STAFF RECOMMENDATION
2517 Blair Boulevard
April 18, 2018

Application: New construction—addition to outbuilding
District: Hillsboro-West End Neighborhood Conservation Zoning Overlay
Council District: 18
Map and Parcel Number: 10415002700
Applicant: Blaine Bonadies
Project Lead: Melissa Baldock, melissa.baldock@nashville.gov

Description of Project: Application is to construct a second story on top of an existing one-story outbuilding. The existing outbuilding's left facade does not meet the base zoning side setback of five feet (5'). It is between one foot and two feet, eight inches (1' - 2'8") from the left side property line. The outbuilding will not be used as a detached accessory dwelling unit.

Recommendation Summary: Staff recommends disapproval of the addition to the outbuilding, finding that its height, scale, and setback do not meet Section II.B.h. of the Hillsboro – West End Neighborhood Conservation Zoning Overlay design guidelines

blair blvd

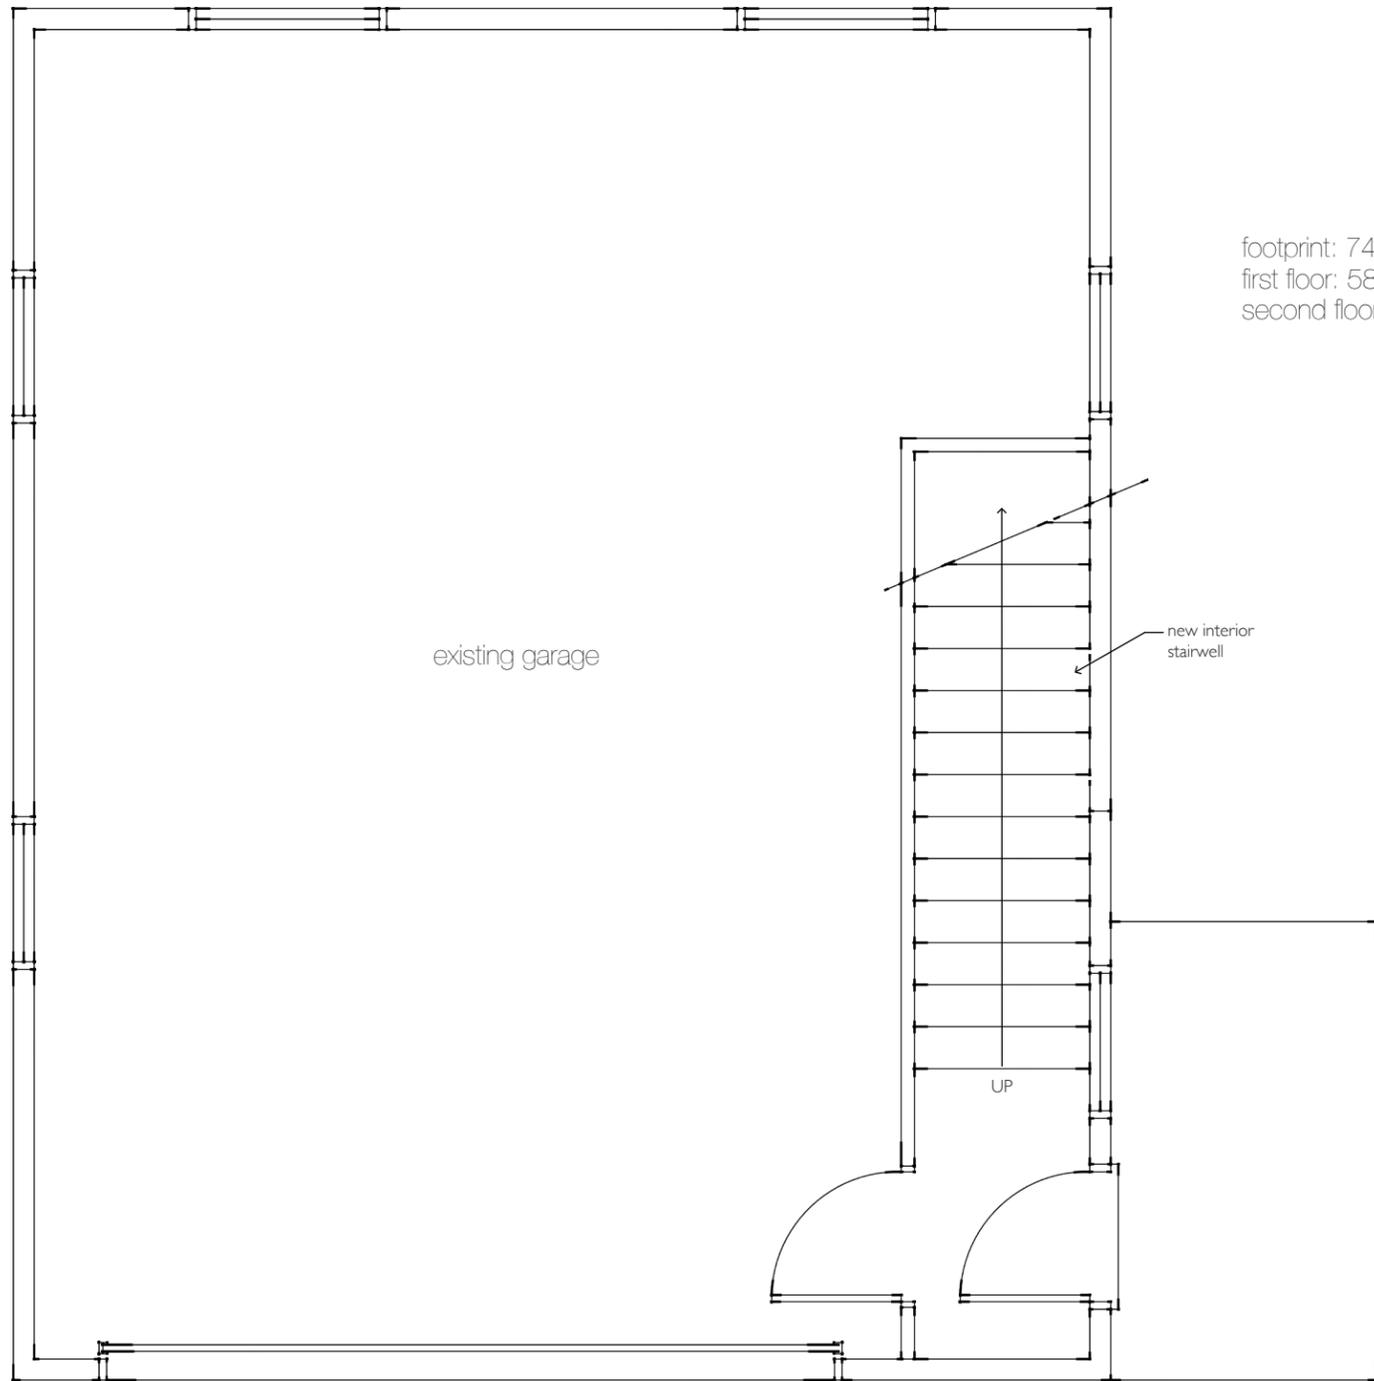
* Base zoning requires a five foot (5') side setback when the outbuilding's footprint is larger than seven hundred and square feet (700 sq. ft.) like this one. The existing outbuilding is seven hundred and eighteen square feet (718 sq. f.t). It does not meet base zoning setback on the left side. The existing structure is just one foot (1') from the left side property towards the front and is approximately two feet, eight inches (2'8") from the side property line at its rear. Staff finds that increasing the height of the outbuilding from one-story to two-stories and from approximately sixteen feet (16') tall to twenty-four feet, nine inches (24'9") tall increases the non-conformity of the setbacks and is not appropriate. Staff therefore finds that the project does not meet Section II.B.h.2 of the design guidelines.

proposed

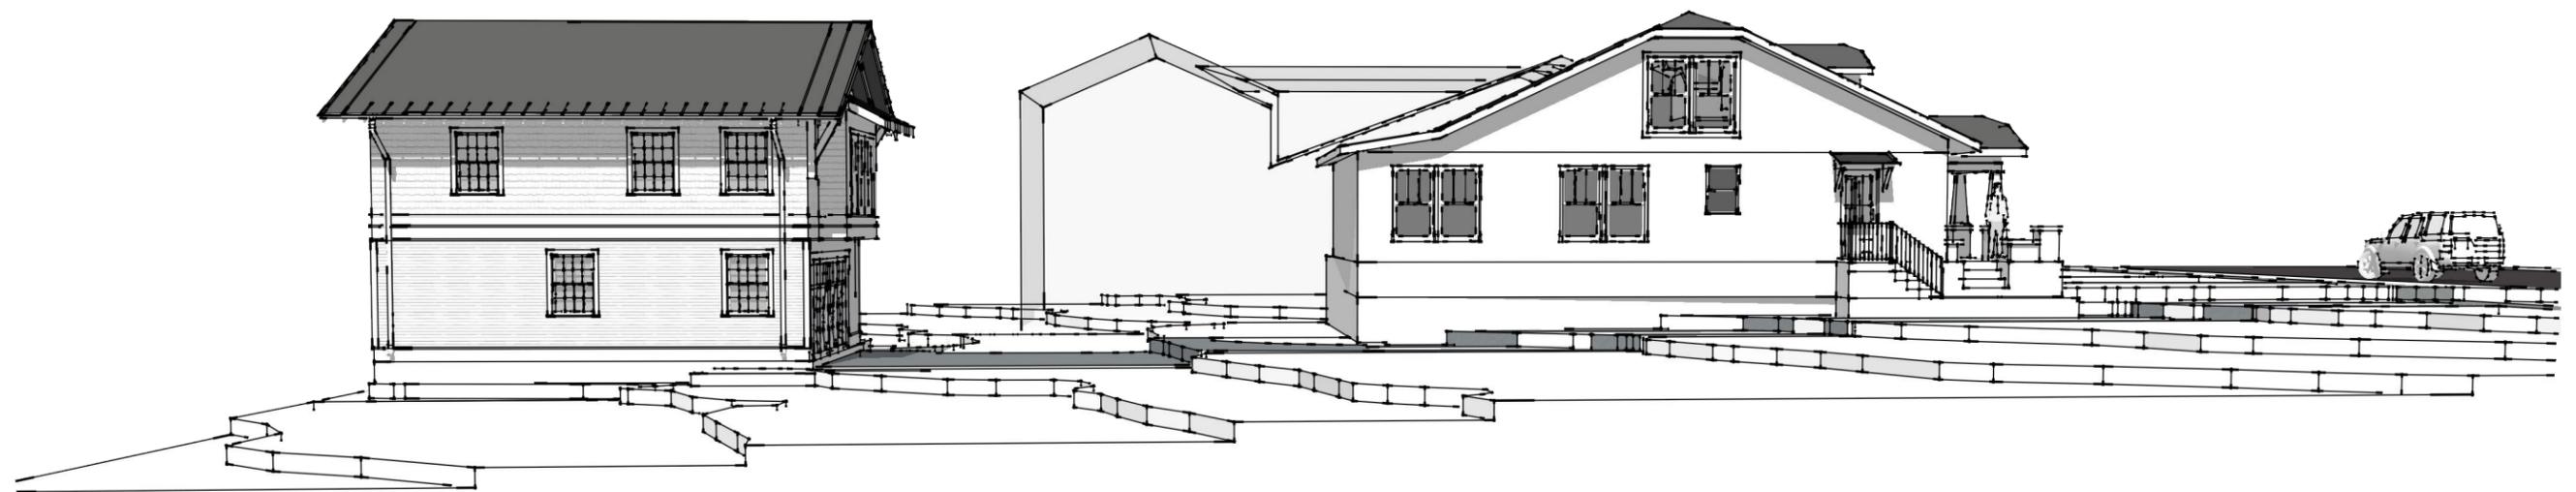
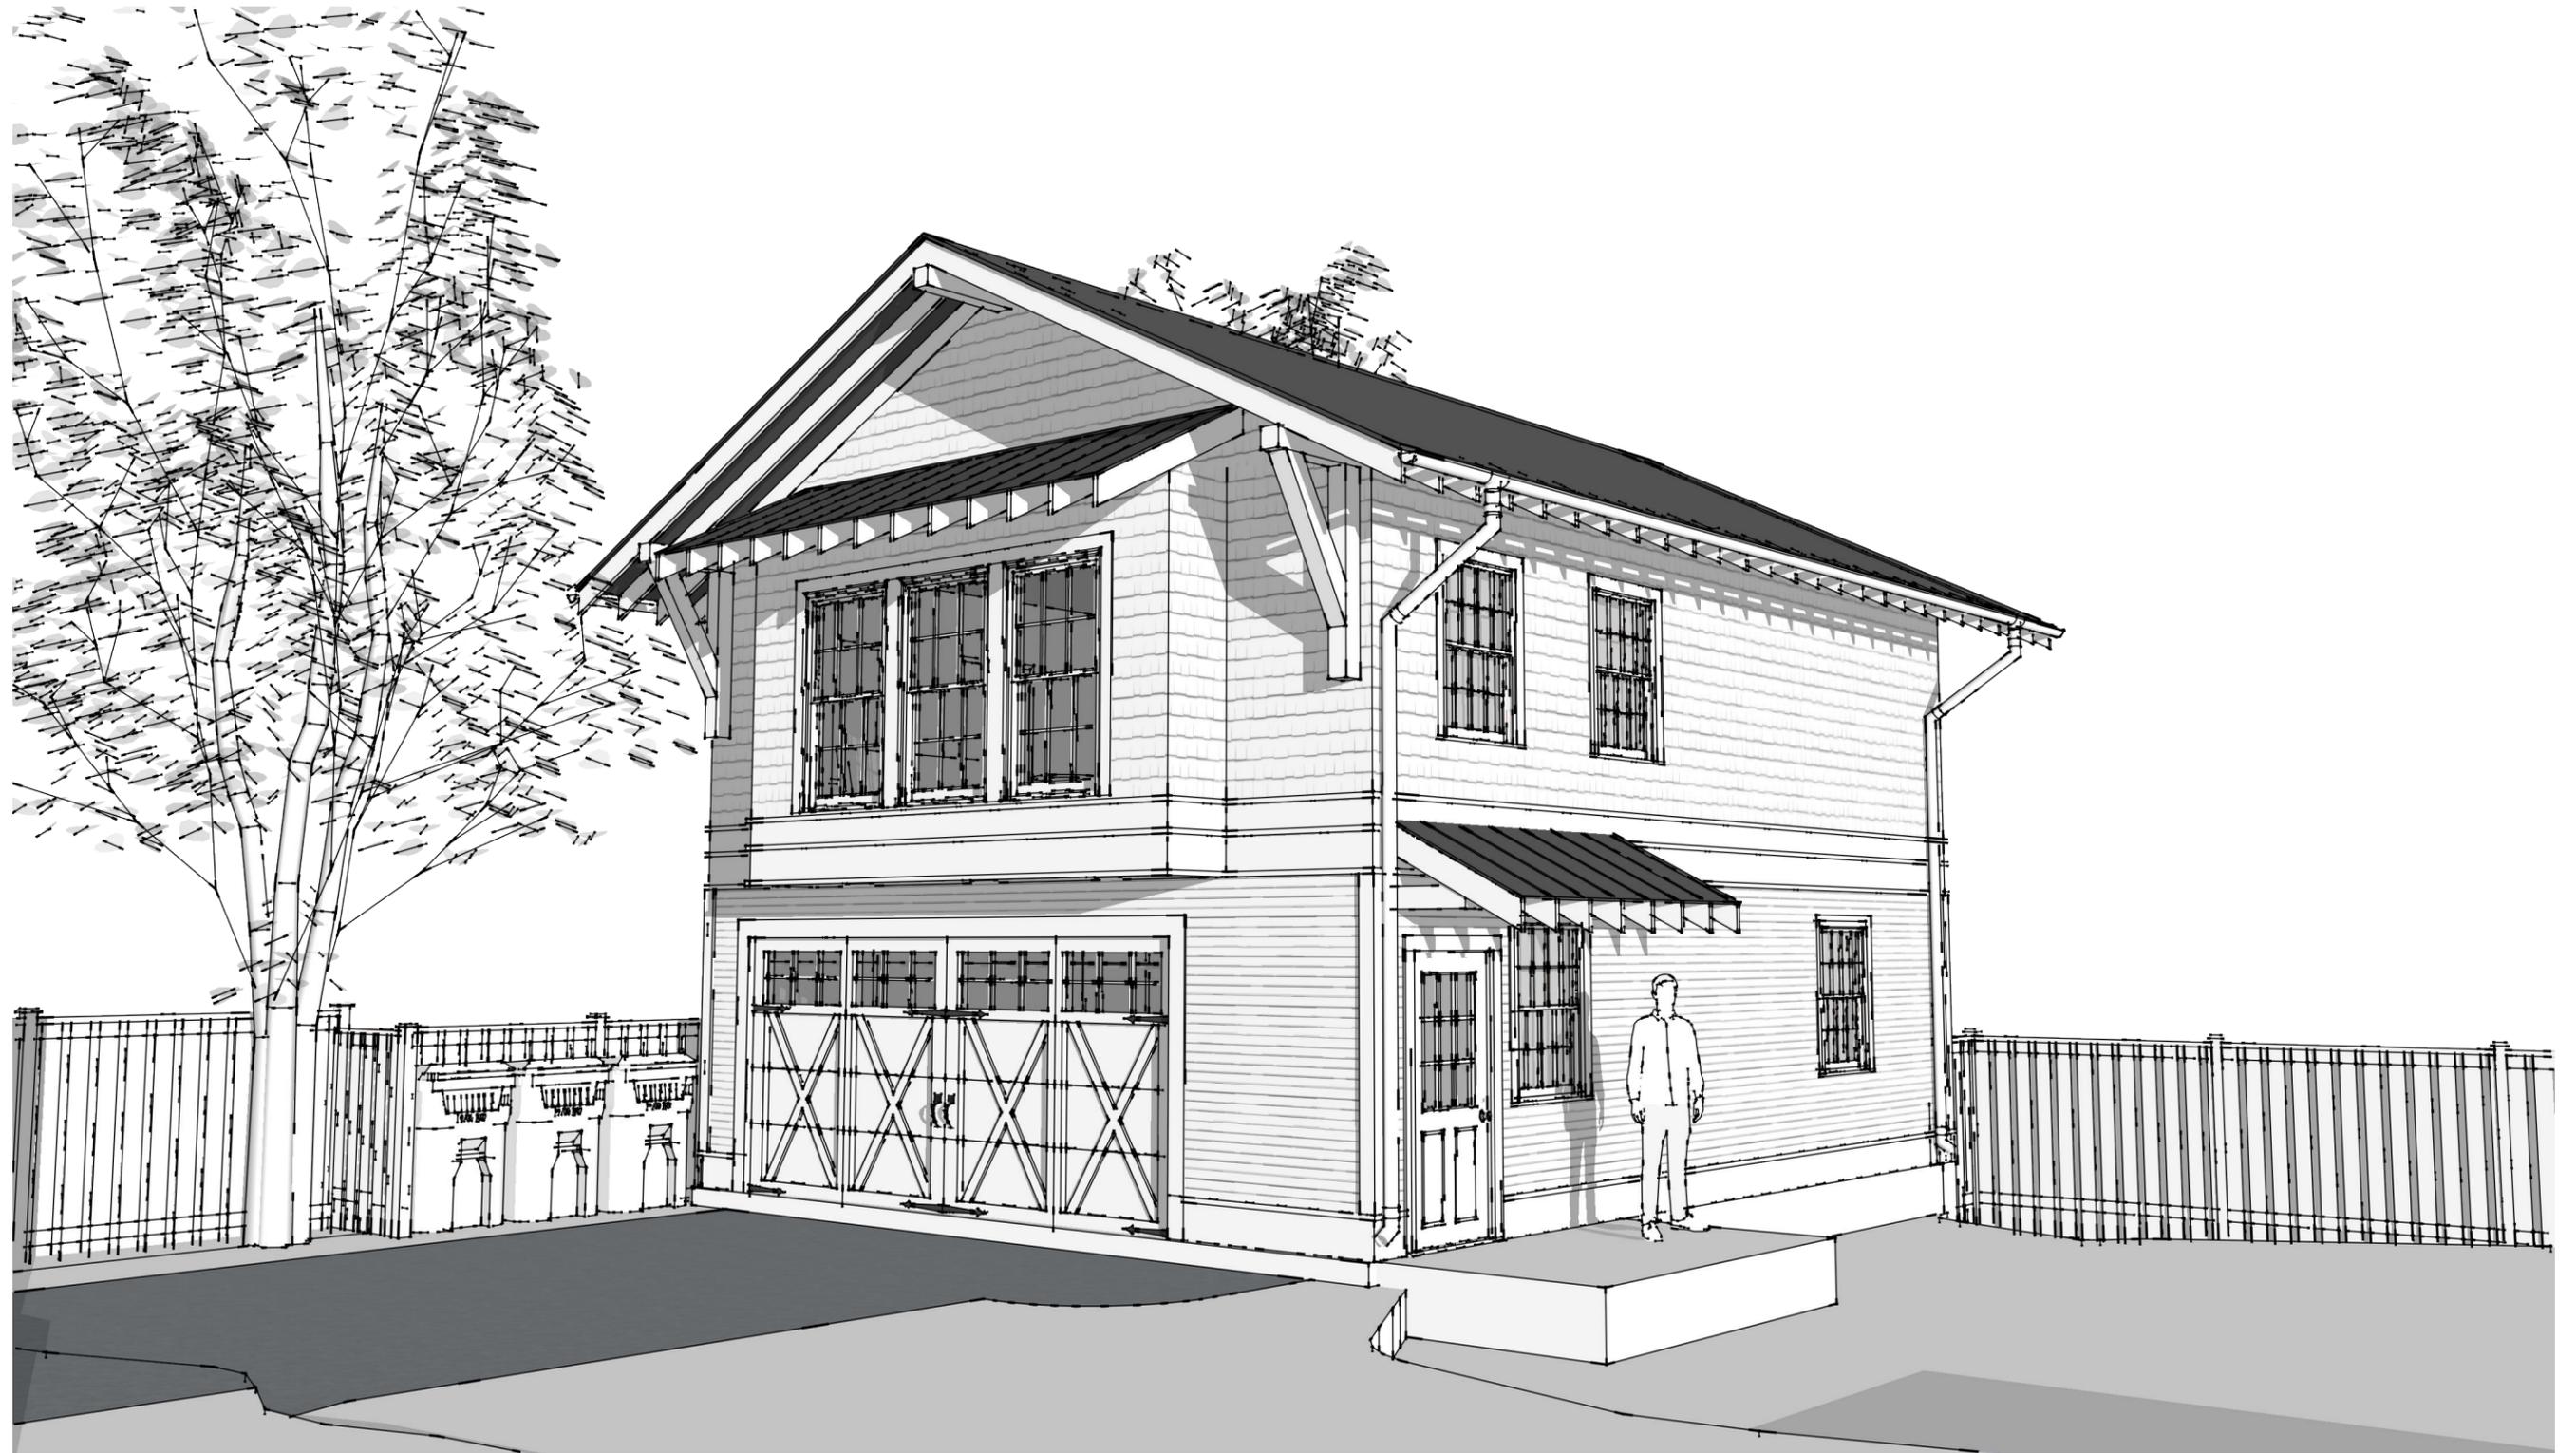
** The proposed addition to the existing outbuilding will create a two-story structure behind an existing one-and-half story historic house. As such, its ridge and eave heights are significantly taller than the historic house and do not meet the design guidelines. The ridge height of the house, from foundation line, is approximately twenty-two feet (22') and its eave height, from foundation line, is approximately ten feet (10'). The average eave height from grade is approximately twelve feet, six inches (12'6"). By contrast, the

proposed addition to the outbuilding will have a ridge height of twenty-four feet, nine inches (24'9") and an eave height of fifteen feet, ten inches (15'10"). The site does slope down from the front of the lot to the rear, but even taking the average eave of the house from grade, the eave height is taller on the outbuilding than on the historic house. Because the proposed eave and ridge heights of the outbuilding are taller than the eave and ridge heights of the historic house, staff finds that the outbuilding's height and scale do not meet Section II.B.1.h. of the design guidelines

sandborn map / vicinity

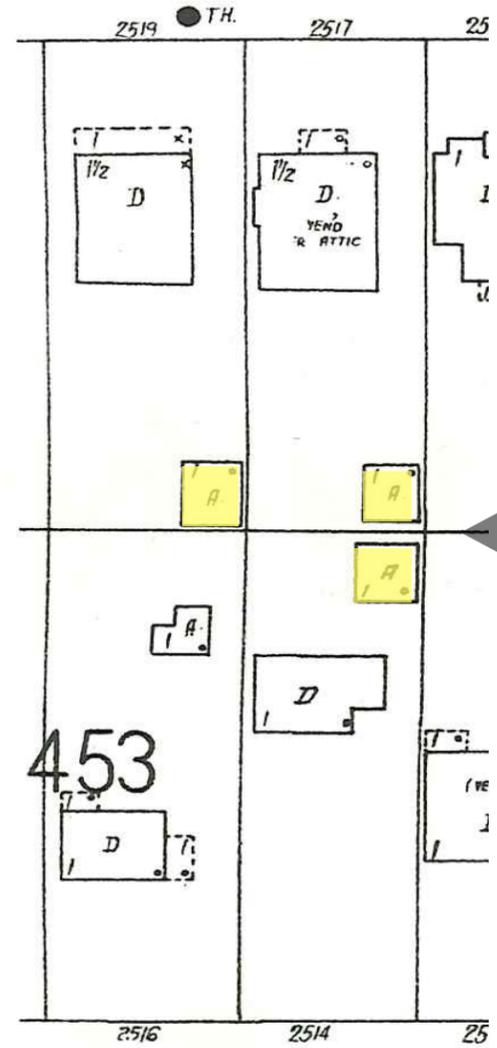
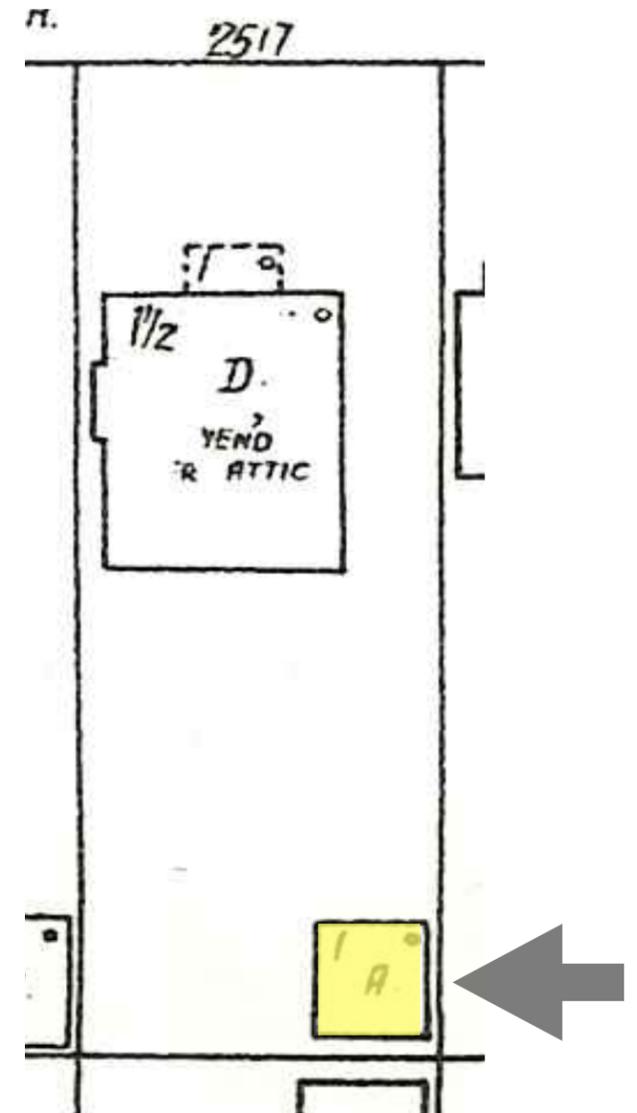
the proposed outbuilding addition exists in the original location of a historic accessory structure.

II.B.C “setback requirements didn’t exist when our historic districts developed so existing conditions sometimes require a little leeway in setbacks required by codes to help new construction fit in with the neighborhood.”
